SEXTON HOUSE
Alterations & Additions at
4 Notting Lane
Cottage Point NSW 2084
to
Garry & Dawn Sexton

North Elevation

Project number	1101	Checked by	WV
Date	March 2013	Scale	1:100
Drawn by	WV		DA05

North Elevation
1:100

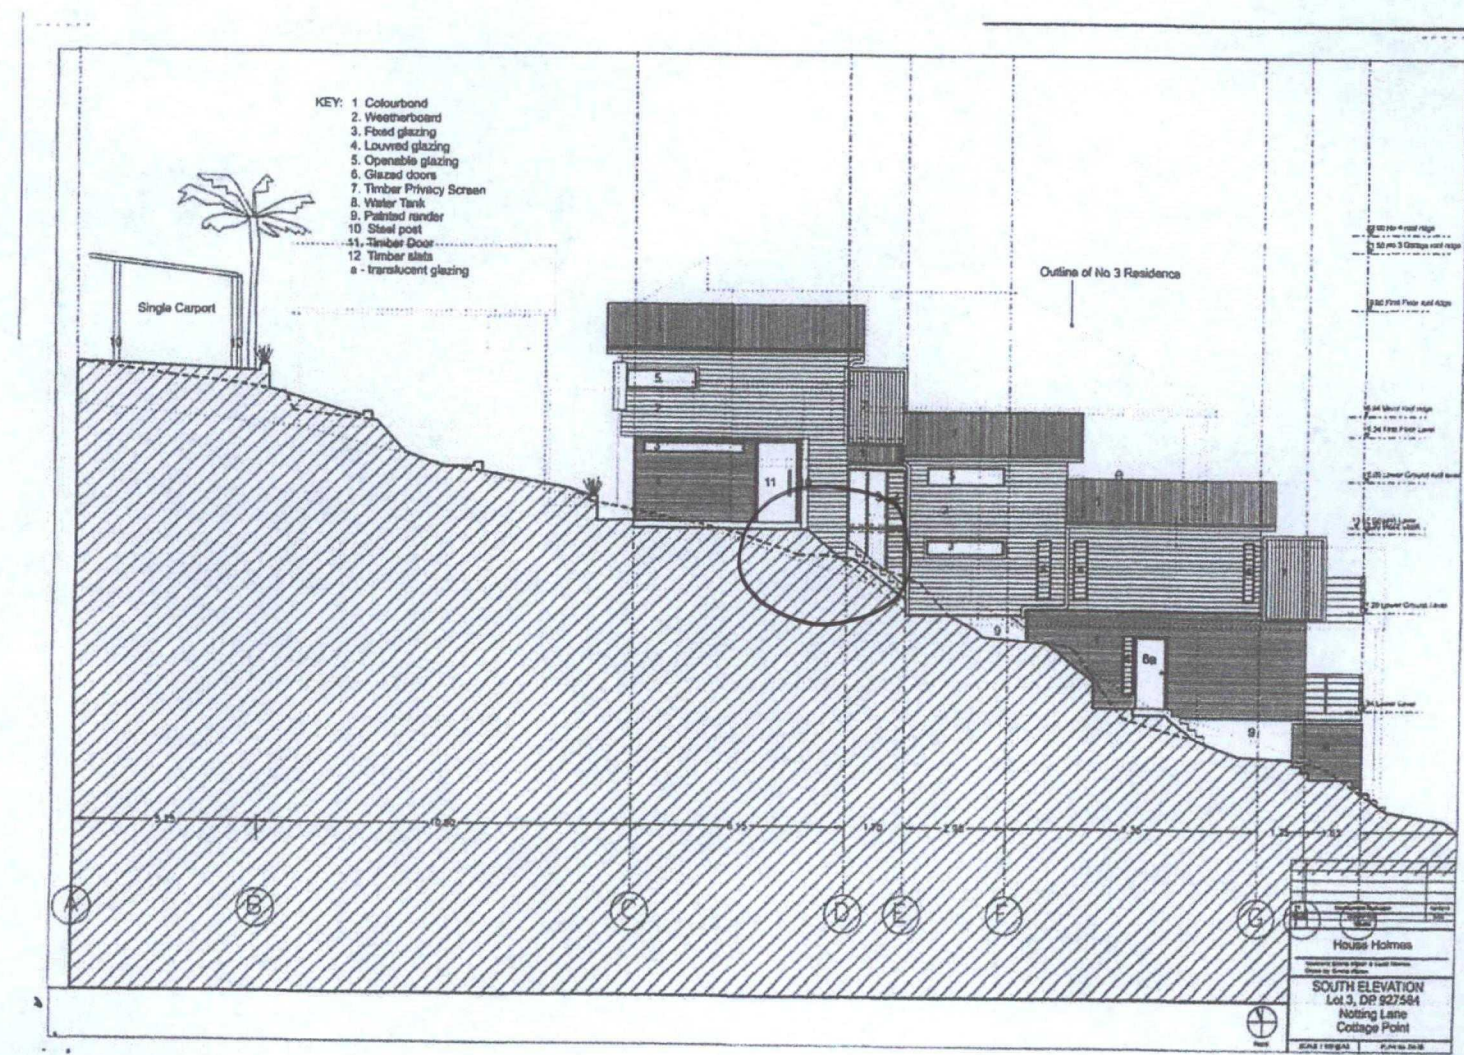
This area is too high.
Should be similar to what was originally approved

NO SUPPORTING WALL SHOWN -
GROUND SHOULD SLOPE DOWN
FOLLOWING THE NATURAL FALL OF
THE LAND
